OUR TOWN HALL PROJECT

PROJECT STATUS	Riba Stage 5		
CLIENT	Manchester City Council		
PROJECT	Our Town Hall		
DRAWING TITLE	Chimney Number CS14 proposed repairs		
SIZE & SCALE	A2: As indicated		
DRAWING STATUS	S4 - Construction		
JOB NUMBER	236959		
DRAWING NO.	OTH-PUR-TH-RF-DWG-A-4174 04		REV
© PURCELL 2012. PURCELL IS THE TRADING NAME OF PURCELL MILLER TRITTON LLP

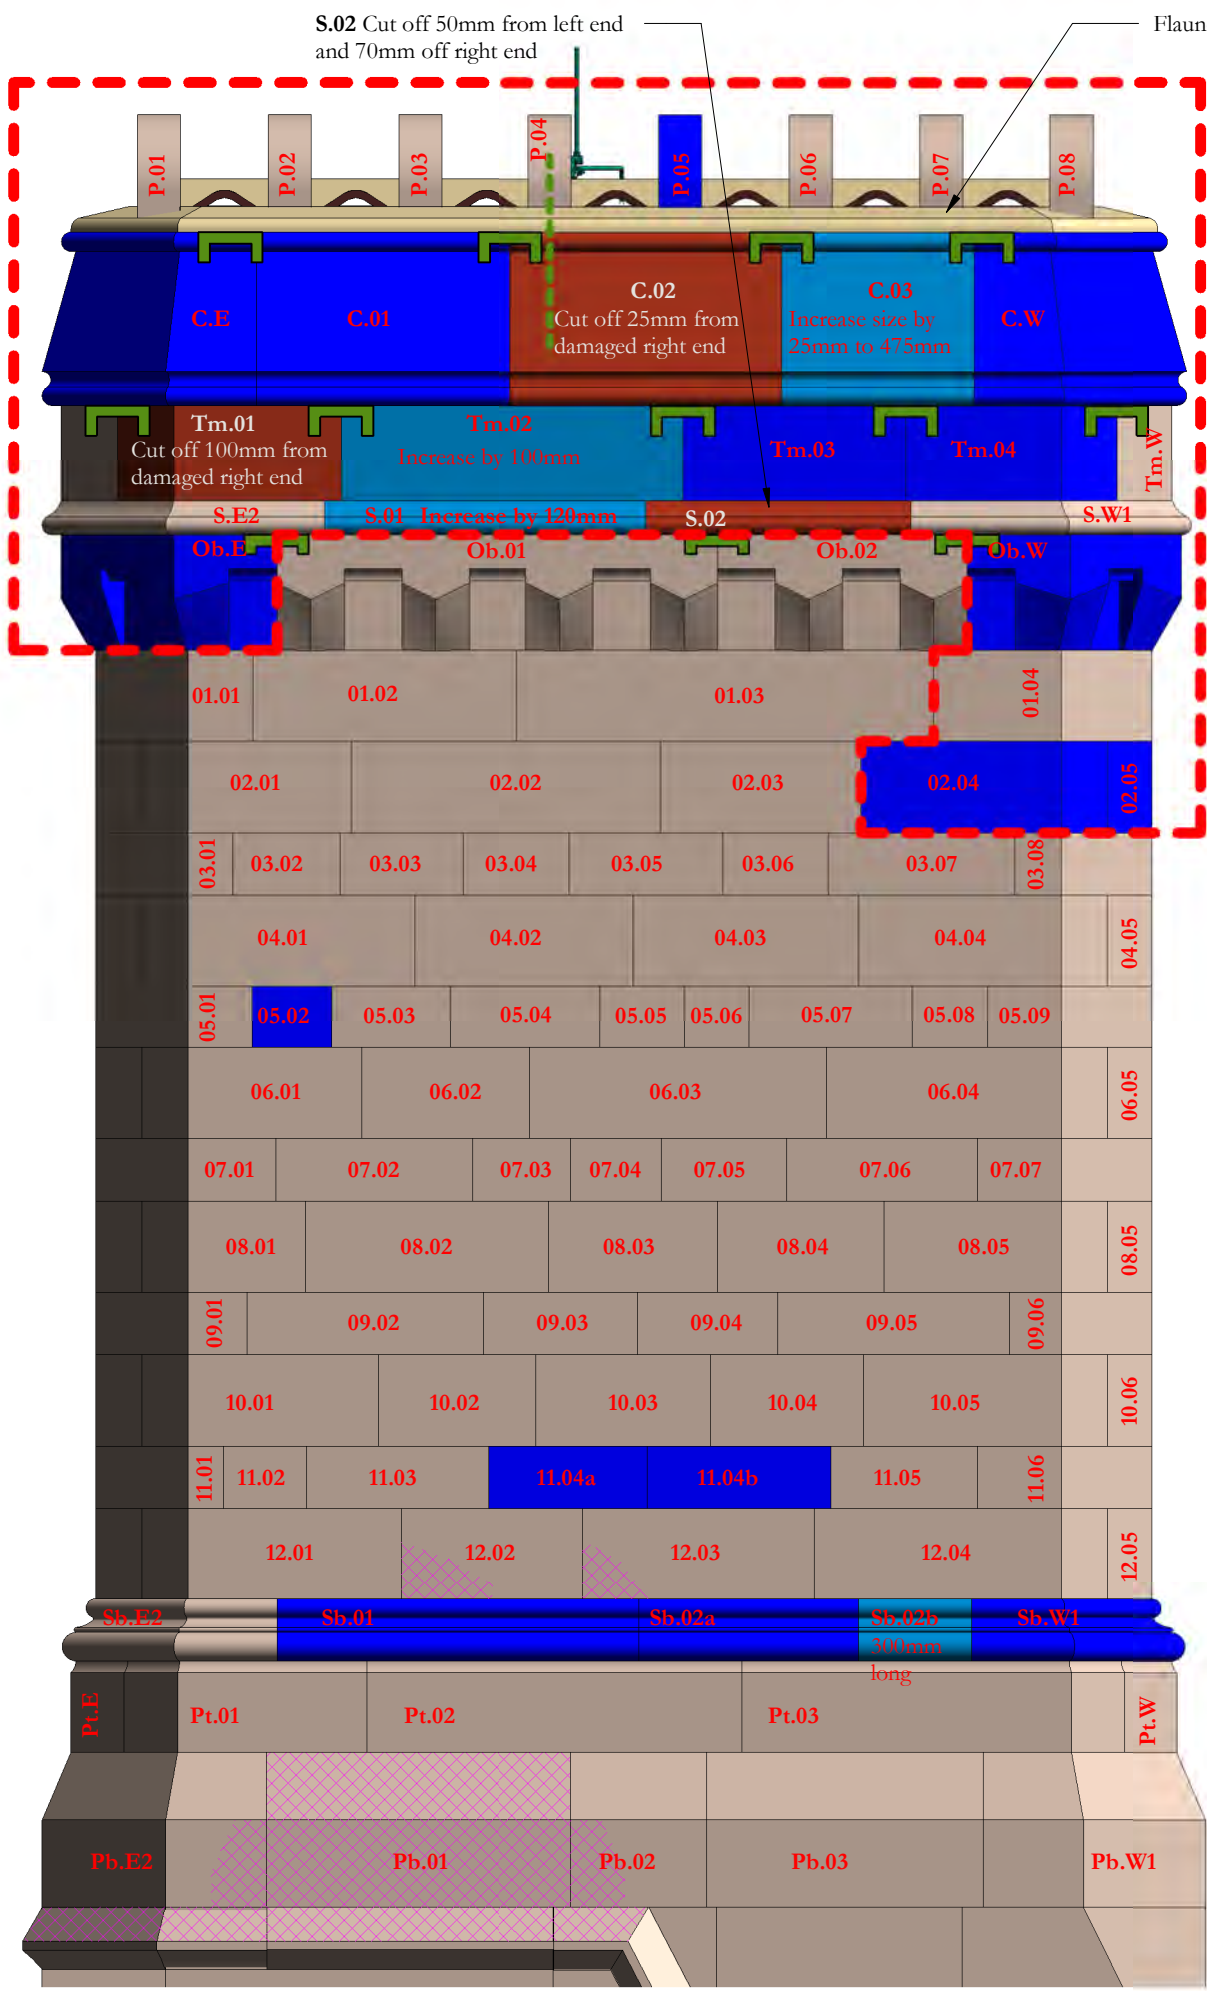
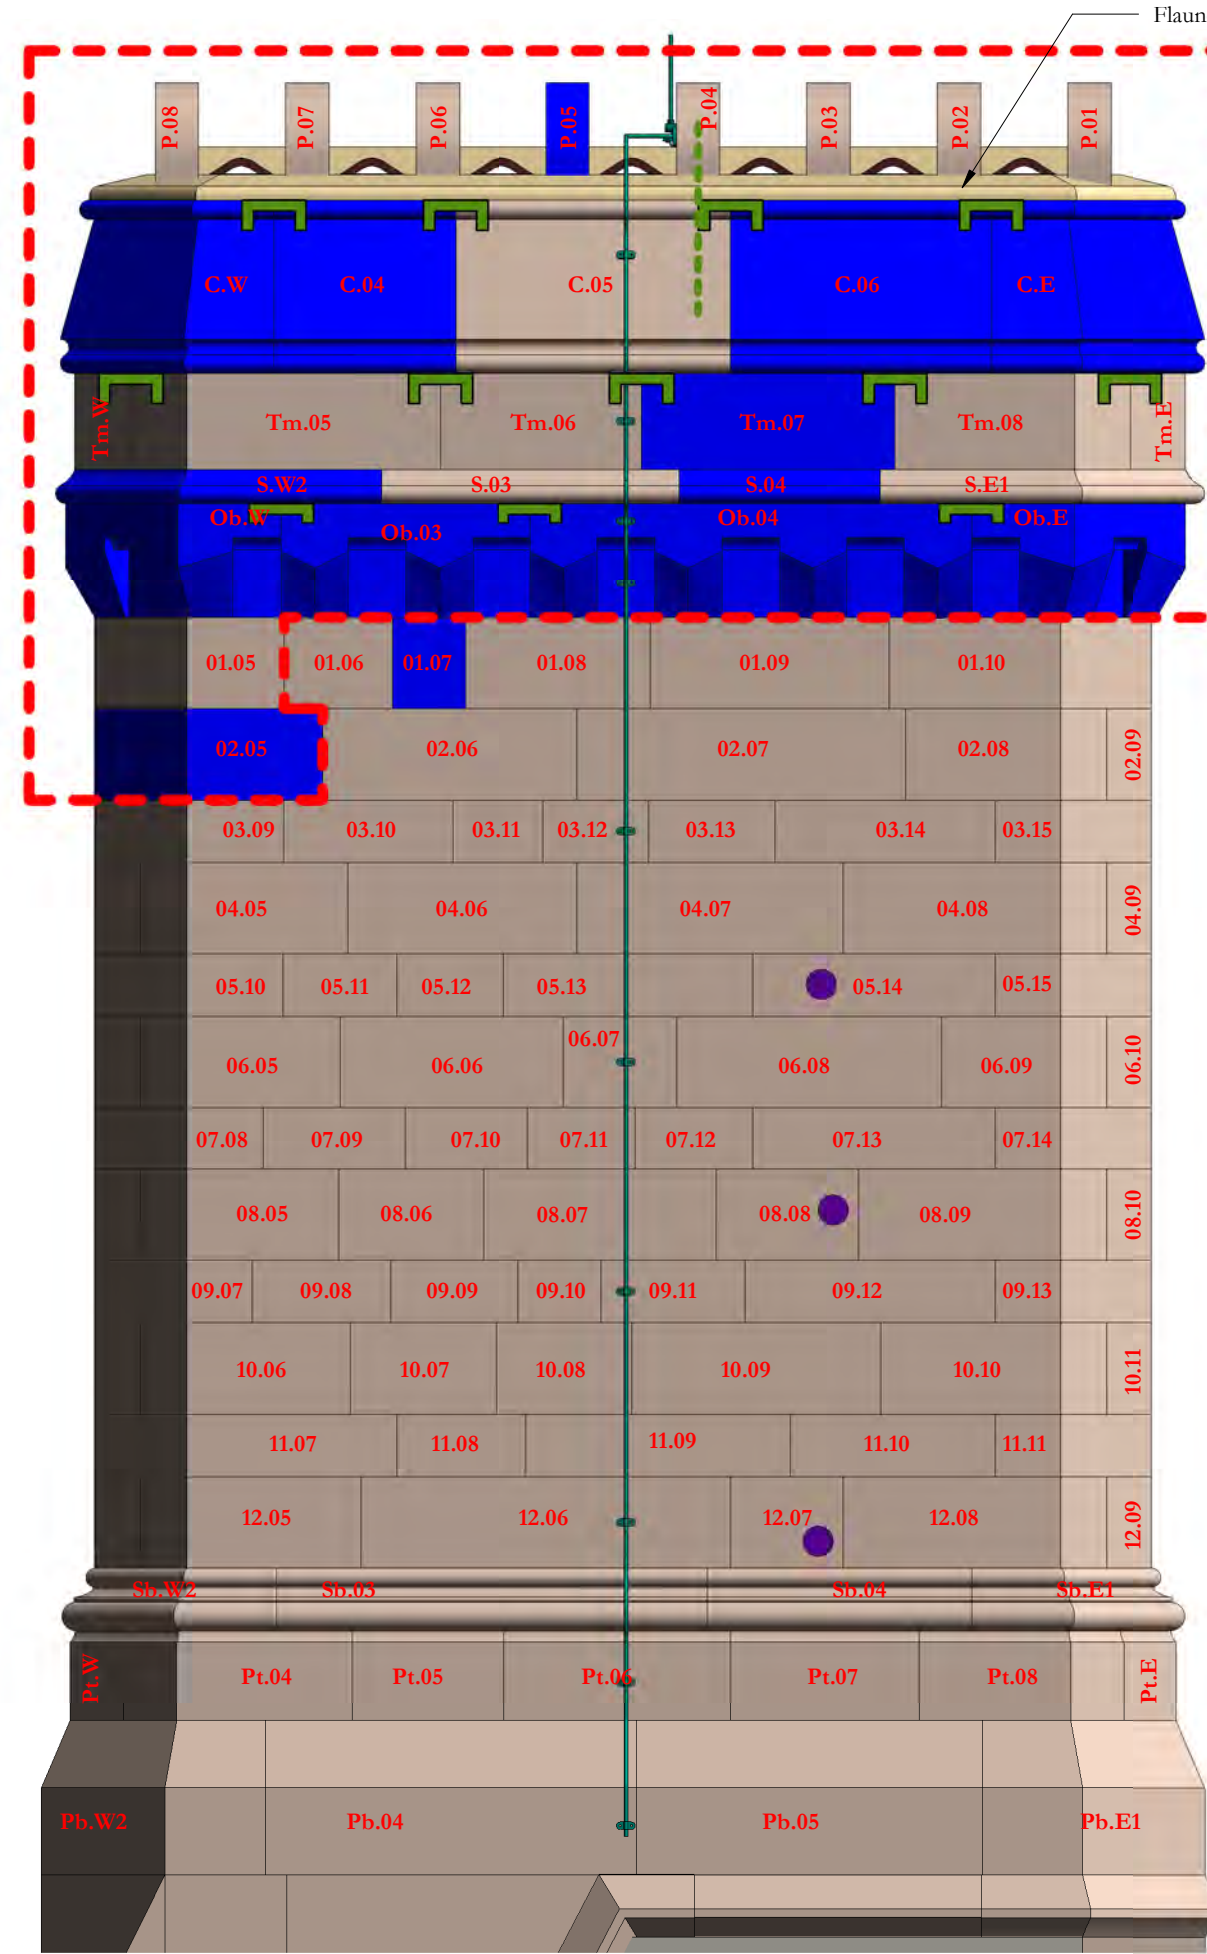
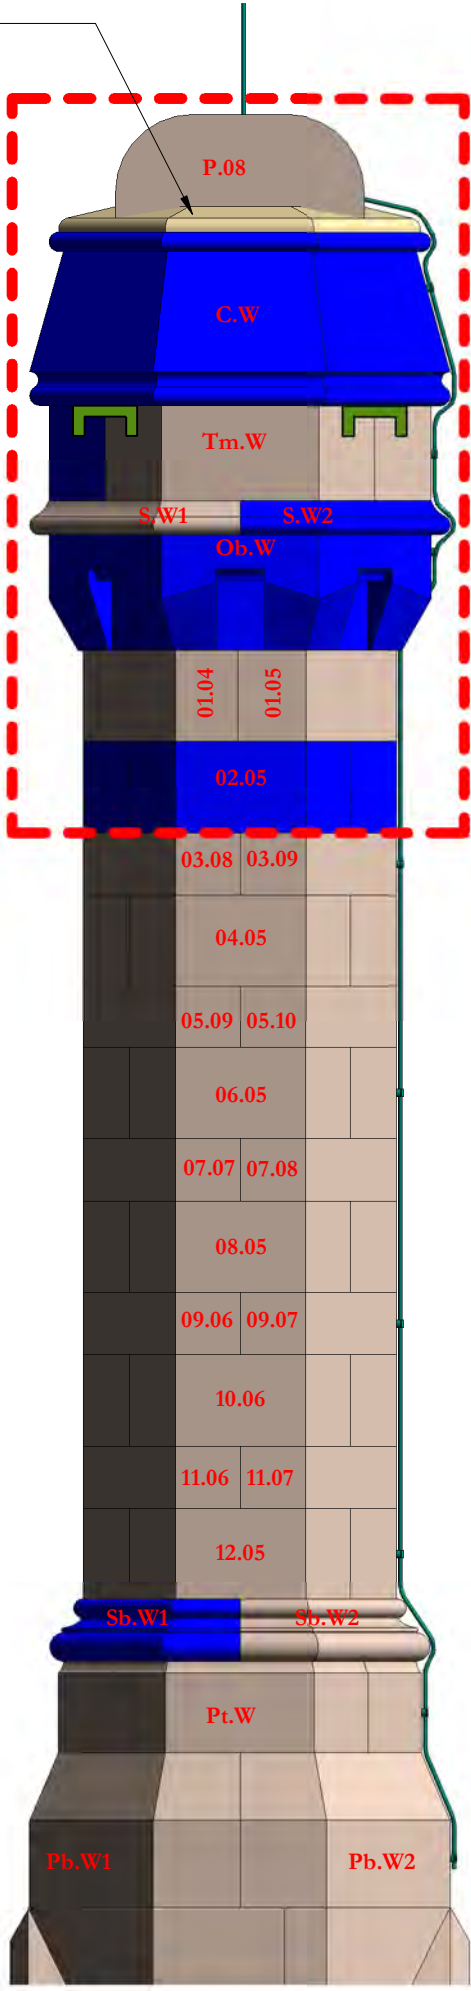
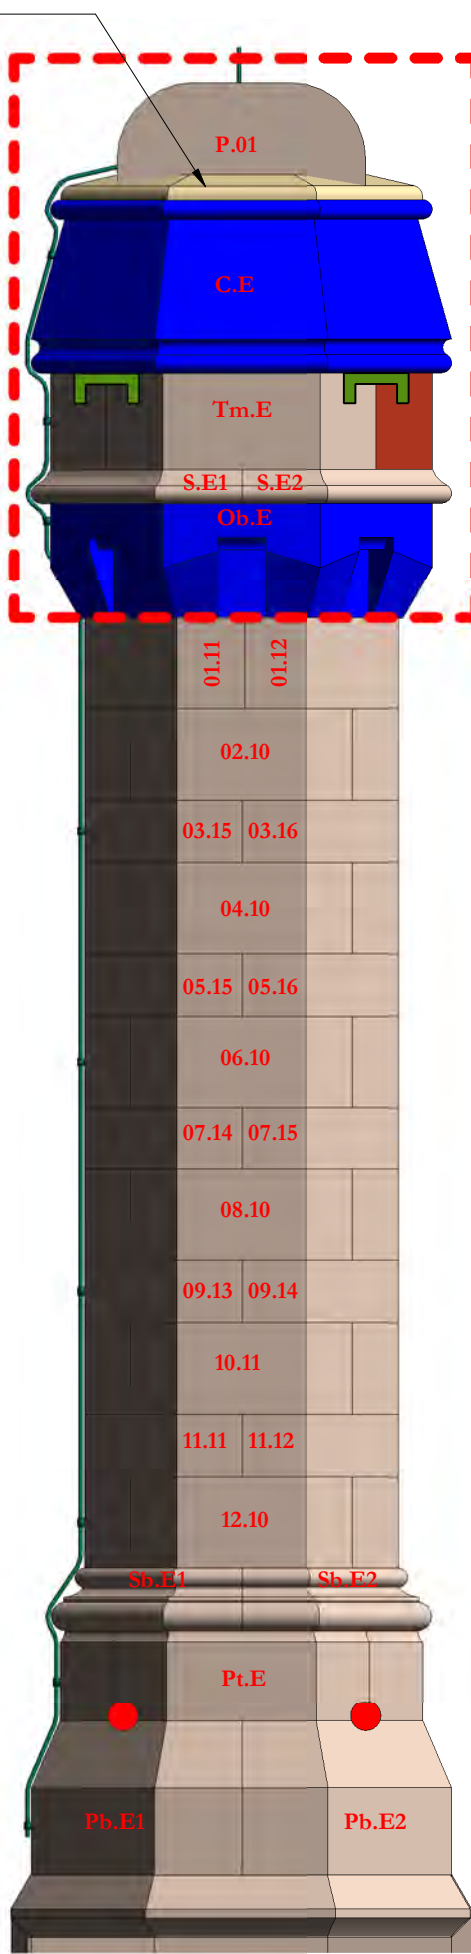
Revision 04: Additional stone replacement 11.04a, 11.04b and Sb02a added. Cramps moved down from string course to Ob course. Lightning protection added and bronze dowels added to feather reference P.04
